Planning Application: 25/1410/FH

66-68 Sandgate High Street – 8 Residential Flats across 4 storeys plus Roof Space

Resubmission of:

25/0057/FH – 9 Residential Flats across 4 storeys plus Roof Space

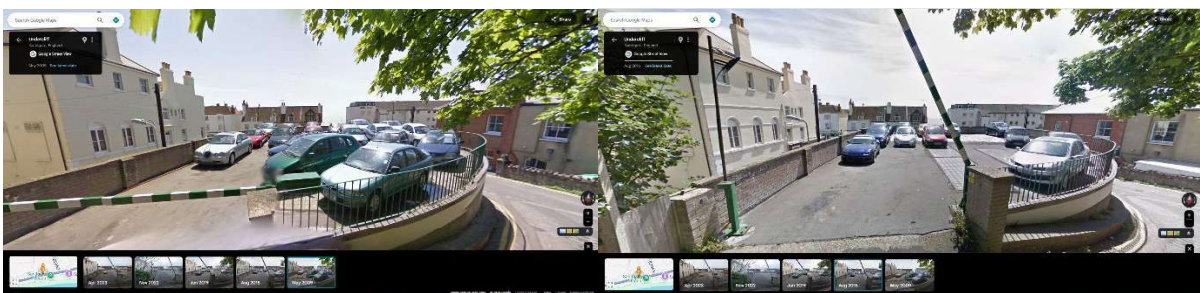
Whilst we understand this as an approach we do not agree that the use of this access point for residential purposes is a continuation of a safe and established use.

As a garage show-forecourt, all vehicles were reversed onto the upper platform and exited on to the Undercliff in a forward motion which is significantly safer in terms of visibility splays and the adjacent unprotected bend.

This can also be seen from google map historic aerial views that show all cars parked facing forward to exit for the last 15 years.

This can be also seen from the photo included on drawing 6318-CON-00-XX-DR-T-1900, which is the same as the 2009 Google Street View.

A simple resolve would be the loss of one parking space to the rear which would allow vehicles to safely turn within the body of the site.

Views of bend

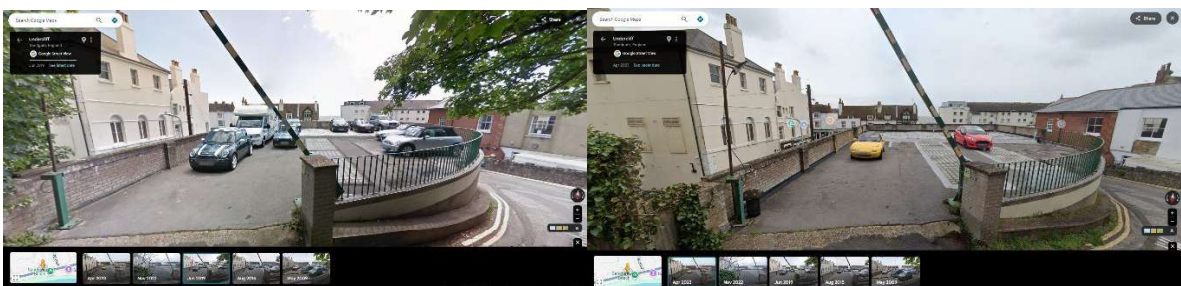
Google Street Views – May 2009 & Aug 2015

Google Street Views – June 2019 & April 2023
